SCALE: 1:1		UNIT: M/M	DRN BY: ERIC	DATE: 3/16-'16	NUTEK CORPORATION		
MATERIAL		CHK BY: YVS		6/2-'16		TITLE: DEI 7146V	
FINISH		APPD BY: VICTOR		6/2-'16		SIZE: A4	
CODE		SHEET OF				DRAWING NO: 10510050	
						REV: 1

SCALE: 1:1	UNIT: M/M	DRN BY: FELIX	DATE: 2016/2/19	NUTEK CORPORATION		
MATERIAL:	CHK BY: YYS	APPD BY: VICIOR	OF:	TITLE: NEW 7145A	DEPT: 10510070	REV: 2
FINISH:	CODE:	SHEET:	OF:	SIZE: A4	DEPT: 10510070	REV: 2

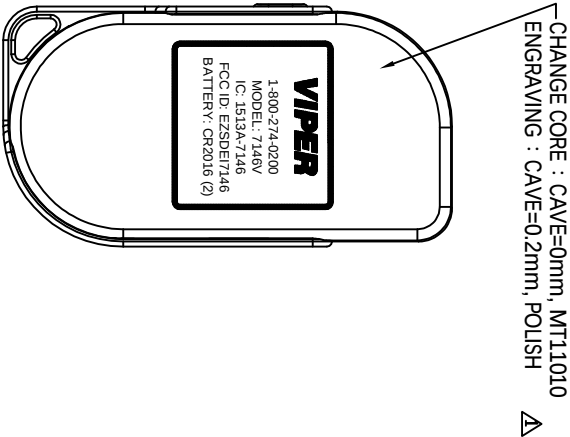
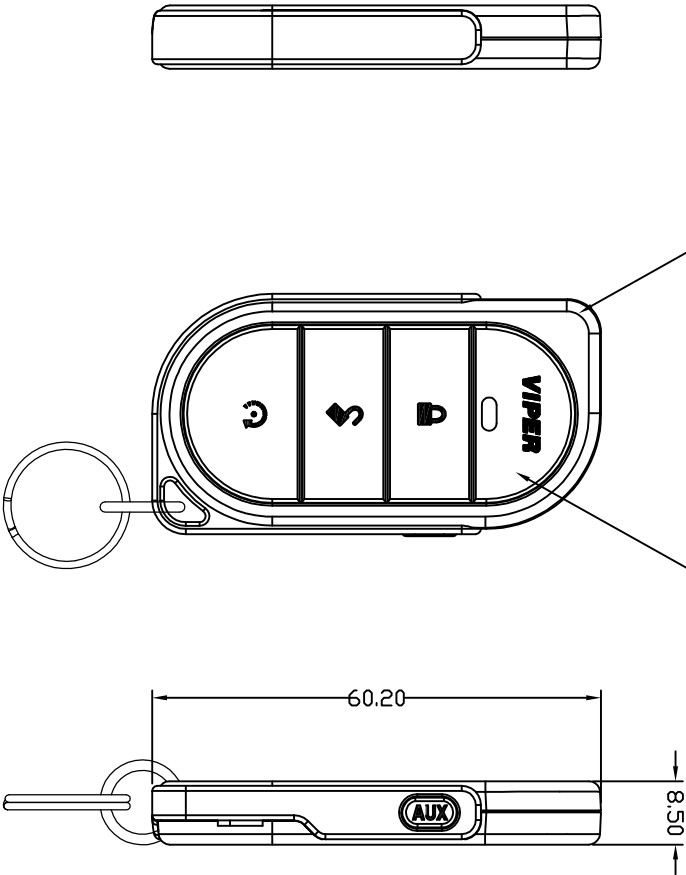
REVISIONS				
REV.	ACC.	DESCRIPTION	DRN.	DATE
Δ	6/2	MAIL	CHANGE ENGRAVING RAISED TO CAVE	6/2-'16
Δ

CHANGE CORE : CAVE=0mm, MT11010
ENGRAVING : CAVE=0.2mm, POLISH Δ

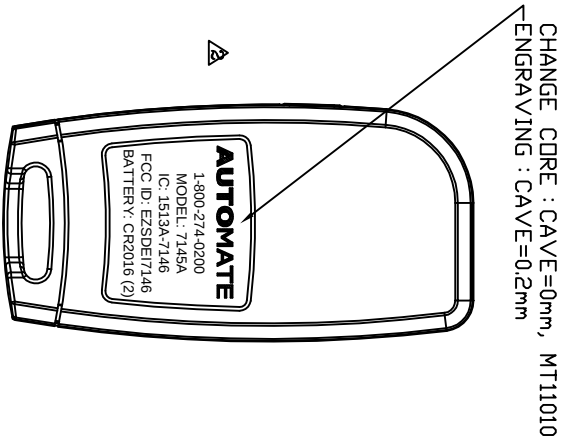
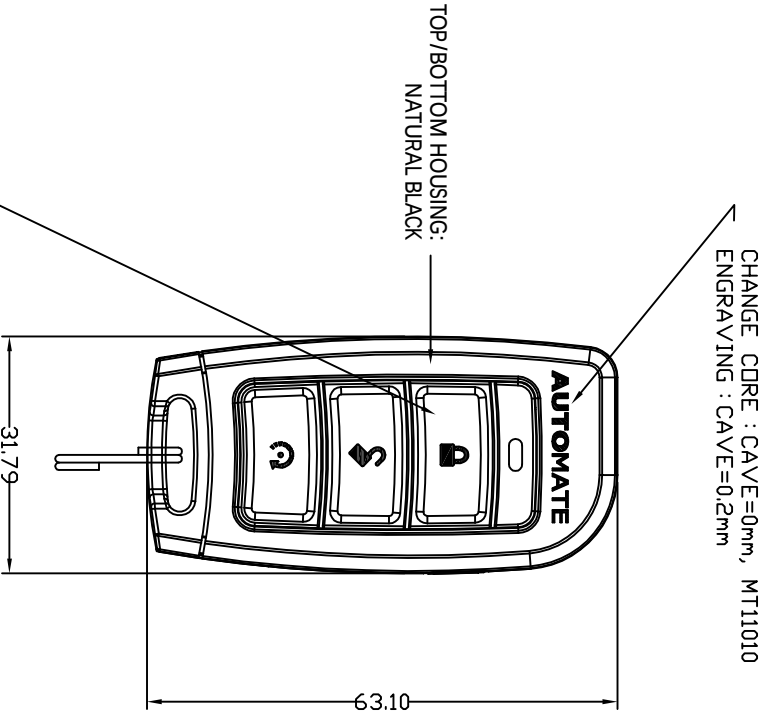
REVISIONS				
REV.	ACC.	DESCRIPTION	DRN.	DATE
1/A		ADD P/N	FELIX	2016/3/31
2/A		MODIFY ENGRAVED	FELIX	2016/4/8
